Addendum No. 1

RE: Contract # C204471
WBS # 45446.3.1
FEDERAL-AID NO. NHS-0421(072)
Wilkes County (U-5312)
US-421 FROM EAST OF NC-16 TO US-421 BUS.

The following revisions have been made to the Utility Construction Plans.

LOCATION: US 421 FROM NC 16 TO US 421 BUSINESS IN WILKESBORO
TYPE OF WORK: WATER AND SANITARY SEWER RELOCATION

PROJECT REFERENCE NO.	U-5312	SHEET NO.	UC-26
DESIGNED BY:	B. CLAWSON		
DRAWN BY:	R. MOSS		
CHECKED BY:	B. CLAWSON		
APPROVED BY:			
REVISIED:	11-2-23		
MUNICIPAL ENGINEERING SERVICES COMPANY, PA.	P.O. BOX 97 GARNER, NC 27529 (919) 772-5393		
		UTILITY CONSTRUCTION PLANS ONLY

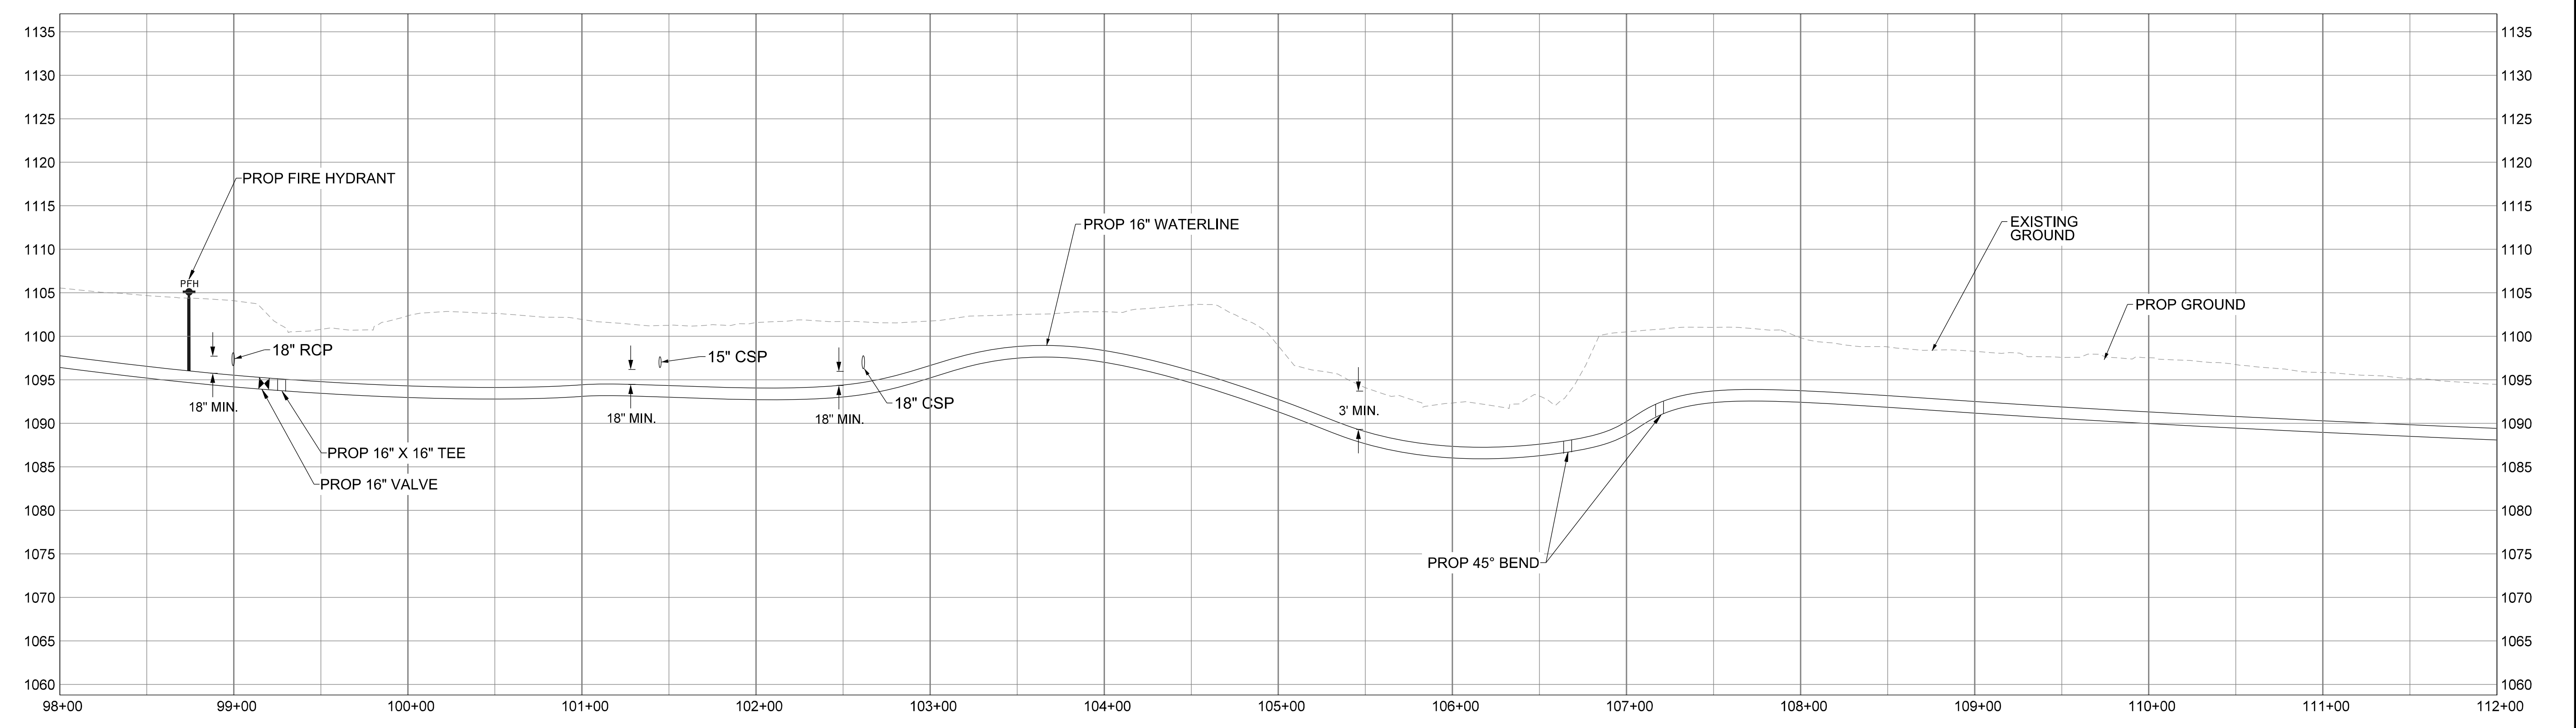
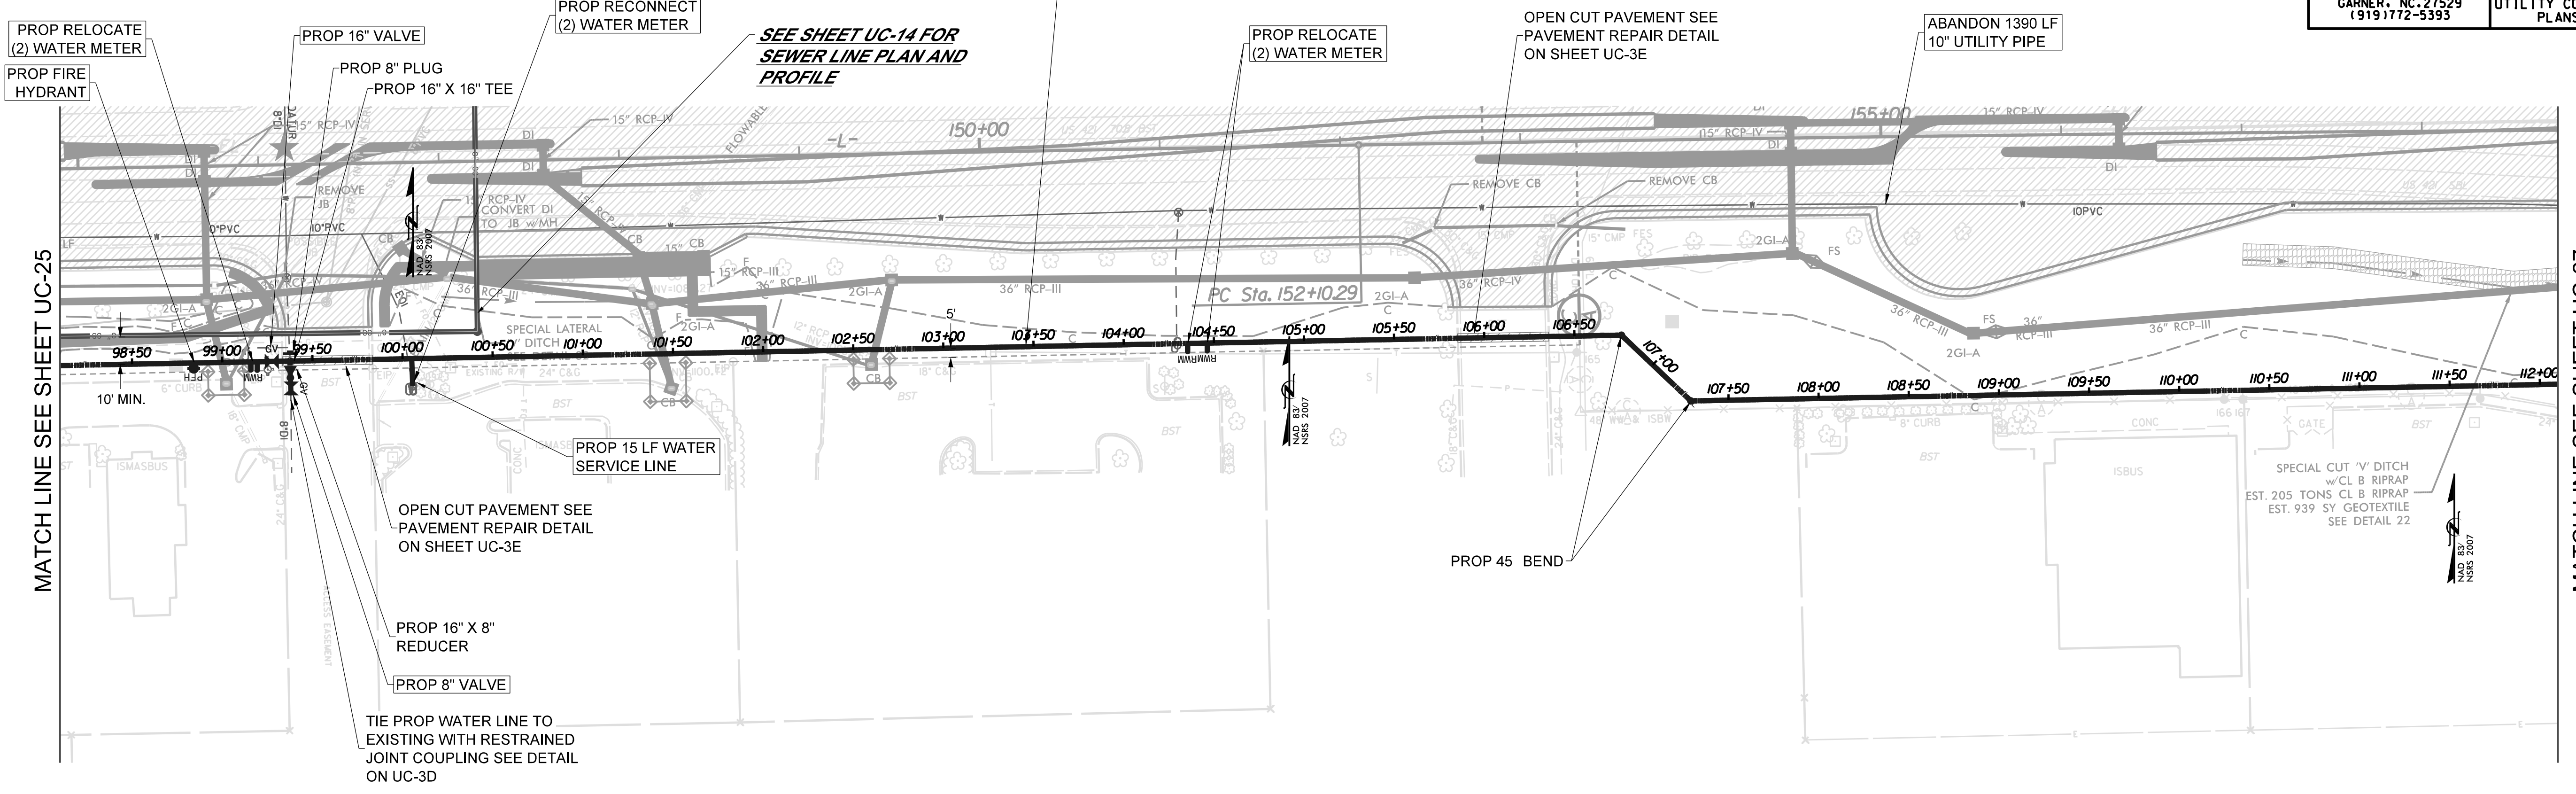
UC-26	Revised Note #1 to state "Waterline material shall be DIP-Class 350 (All Open Trench Installations), HDPE-DR7 (Directional Bore Installations), Copper (Service Installations)".
UC-27	North arrow added. Revised Note #1 to state "Waterline material shall be DIP-Class 350 (All Open Trench Installations), HDPE-DR7 (Directional Bore Installations), Copper (Service Installations)".
UC-28	North arrow added. Labels added in the profile. Revised Note #1 to state "Waterline material shall be DIP-Class 350 (All Open Trench Installations), HDPE-DR7 (Directional Bore Installations), Copper (Service Installations)".
UC-29	Vertical separation adjusted in profile. Revised Note #1 to state "Waterline material shall be DIP-Class 350 (All Open Trench Installations), HDPE-DR7 (Directional Bore Installations), Copper (Service Installations)".
UC-30 thru UC-33	Revised Note #1 to state "Waterline material shall be DIP-Class 350 (All Open Trench Installations), HDPE-DR7 (Directional Bore Installations), Copper (Service Installations)".

- 1 - PROVIDED MORE DETAIL FOR BENCHED EXCAVATION TRENCHING
- 2 - CHANGED NOTE #1

PROJECT REFERENCE NO.	SHEET NO.
U-5312	UC-27
DESIGNED BY: B. CLAWSON	
DRAWN BY: R. MOSS	
CHECKED BY: B. CLAWSON	
APPROVED BY:	
REVISED: 5/9/23 11/2/23	
MUNICIPAL ENGINEERING SERVICES COMPANY, P.A.	
P.O. BOX 97 GARNER, NC 27529 19191772-5393	UTILITY CONSTRUCTION PLANS ONLY

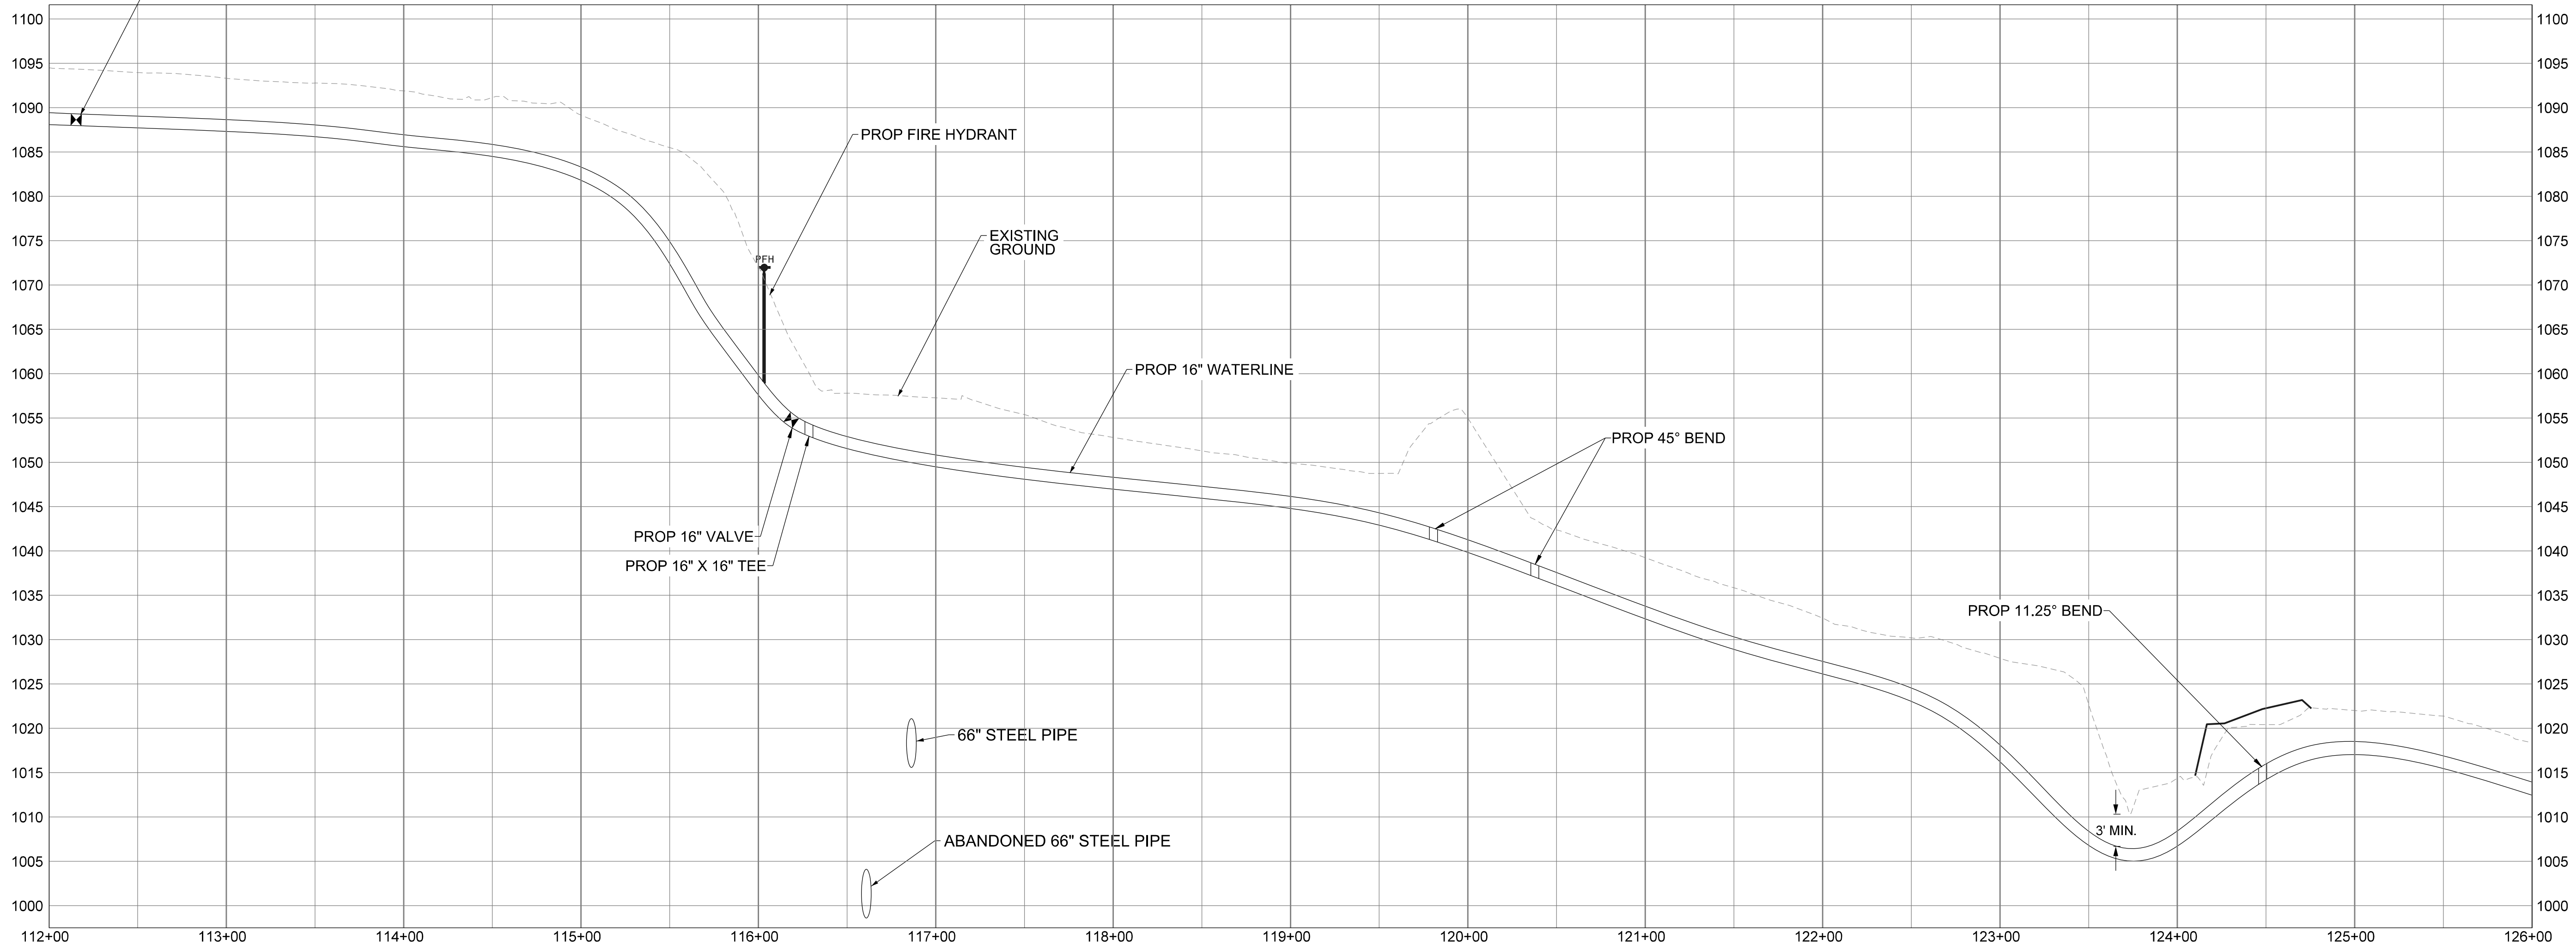
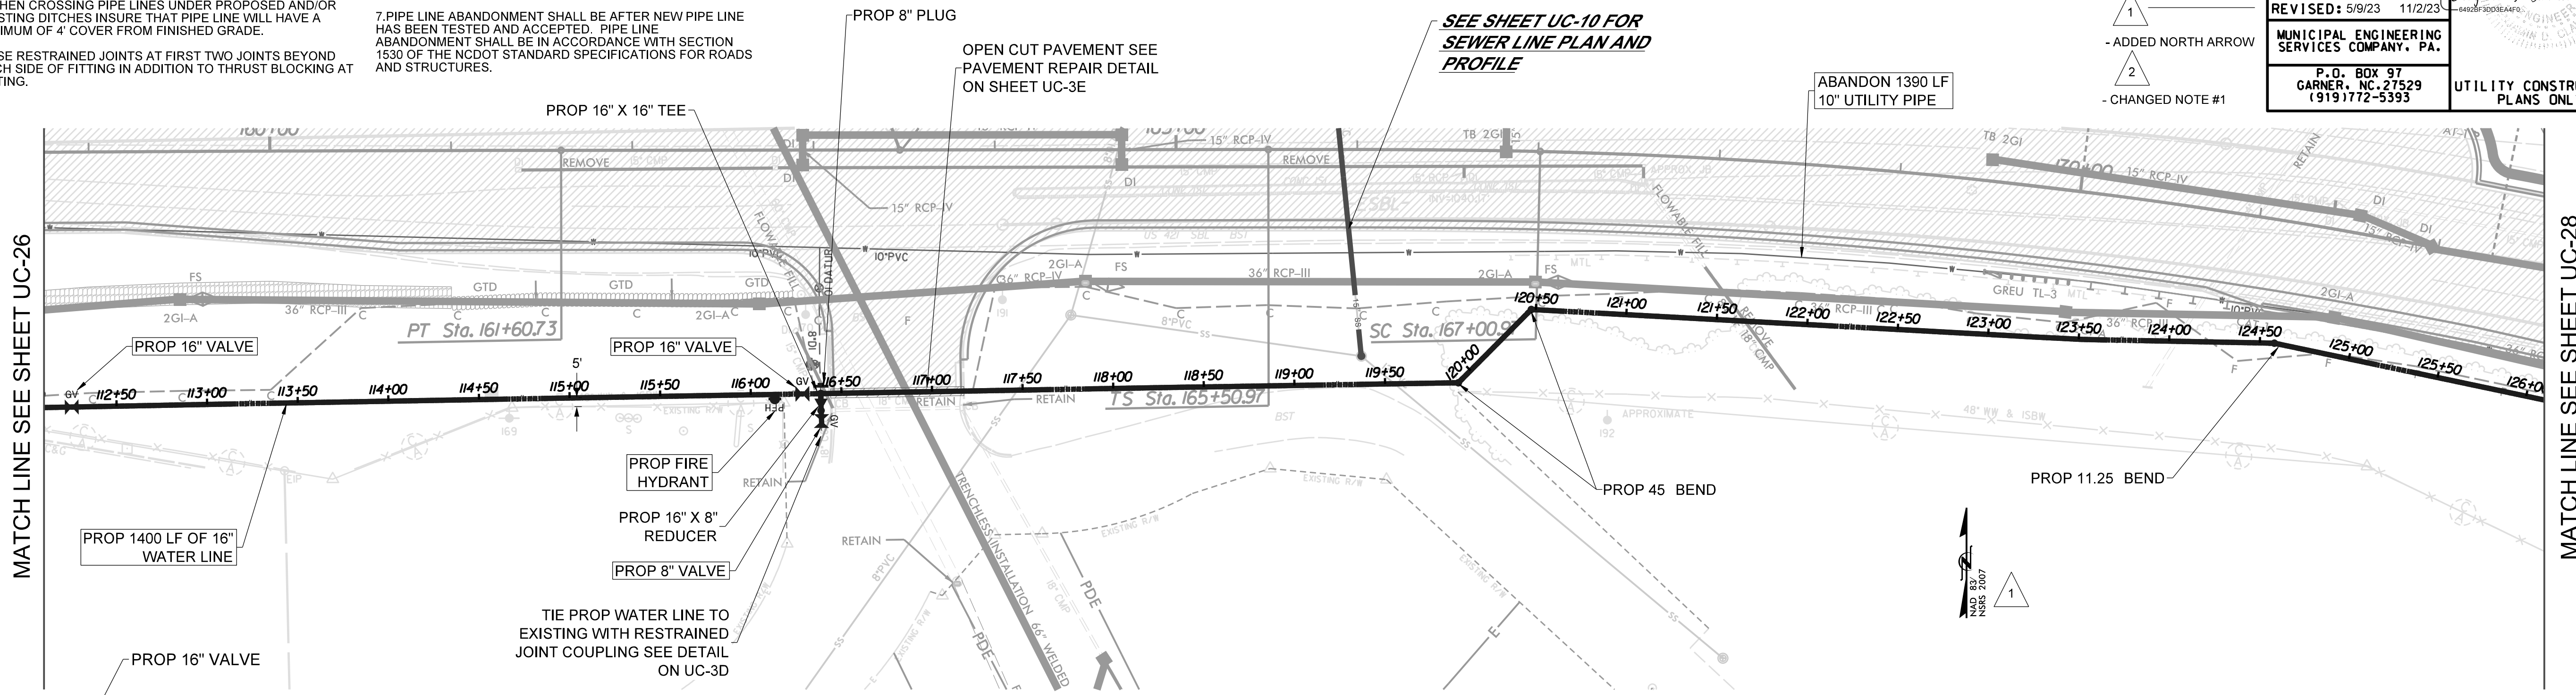
1 - ADDED NORTH ARROW
2 - CHANGED NOTE #1
